**STAFF REPORT
FOR THE HISTORIC REVIEW BOARD**

FILE NUMBER: HDR-25-01

REQUEST: Class II Historic Design Review of the Historic City Hall building at 28825 Willamette Drive to amend the previous design review approval (DR-22-03) and remove the proposed steel awnings from the front and south side of the building.

Amend the previous Class II Design Review approval (DR-22-03) to remove the awnings as required during SHPO review of the project.

NORTHWEST (RIGHT SIDE) ELEVATION

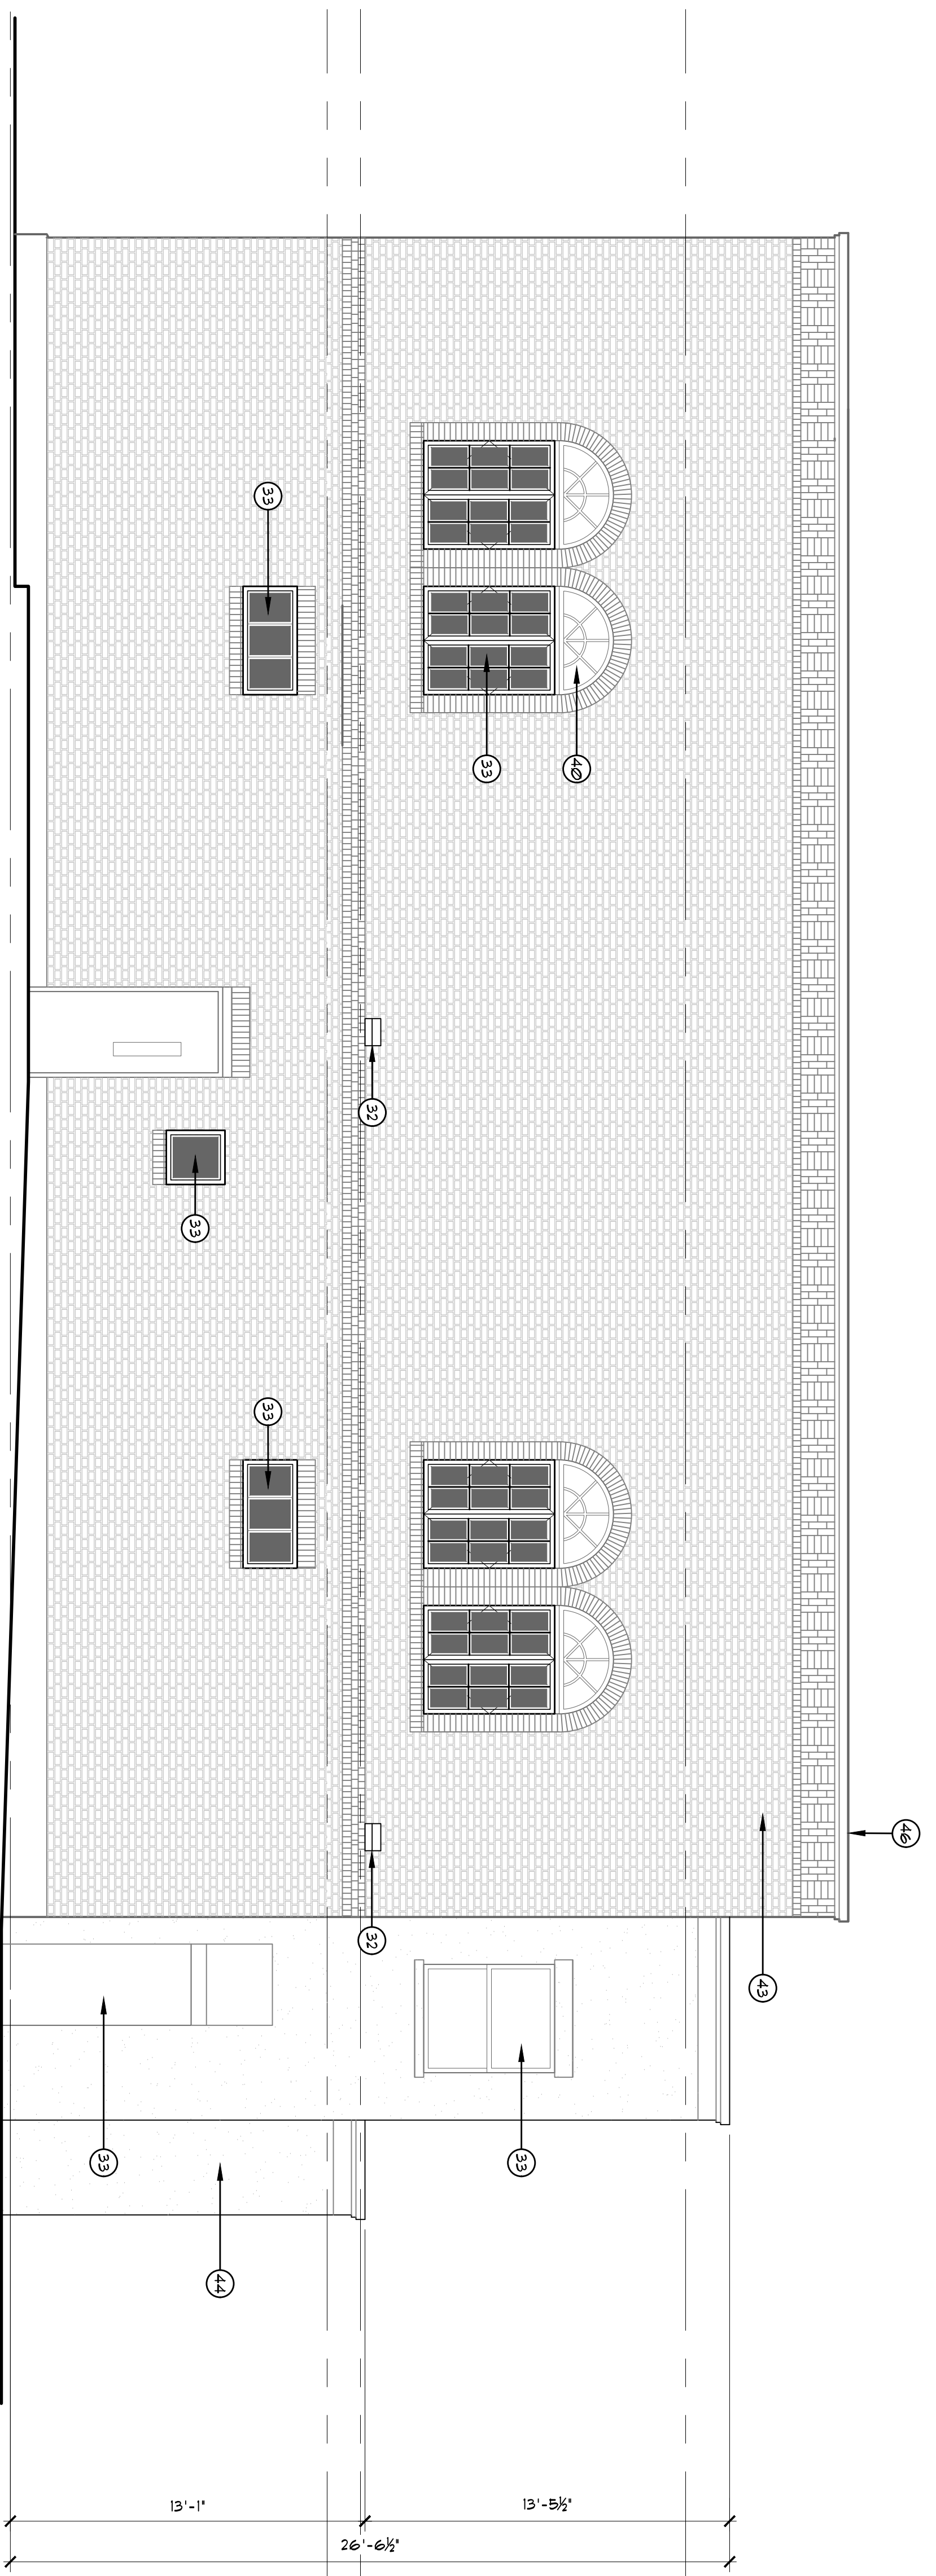
“Regarding the awning, since historically the photos do not indicate a canopy and the submitted materials explain the decision to not install an operational awning, the proposed design of the permanent canopy over the storefronts is incompatible with the historic appearance. If a smaller version was wanted to provide shelter over an entryway, it would be acceptable to place one over the middle entryway since that section has already had significant changes.”

- Regarding the awning, since historically the photos do not indicate a canopy and the submitted materials explain the decision to not install an operational awning, the proposed design of the permanent canopy over the storefronts is incompatible with the historic appearance. If a smaller version was wanted to provide shelter over an entryway, it would be acceptable to place one over the middle entryway since that section has already had significant changes.

Applicant Response: The building has been restored as approved by the Historic Review Board in the DR-22-03 Class II Design Review, except the approved steel awnings on the front of the building were removed as the State Historic Preservation Office (SHPO) found them incompatible with the historic appearance and required removal. Stylistic features have been preserved and incompatible features removed.

- The canopy/ awning elements were a desired addition by the Users to provide shading during the summer months and replace the current deteriorated, non-historic fabric awnings. Operable fabric awnings appear to have been installed early in the building's history at the corner of the building, but were not indicated in the original construction drawings. After much deliberation in our office, we concur with your position that the proposed elements should be omitted from the proposed Project.
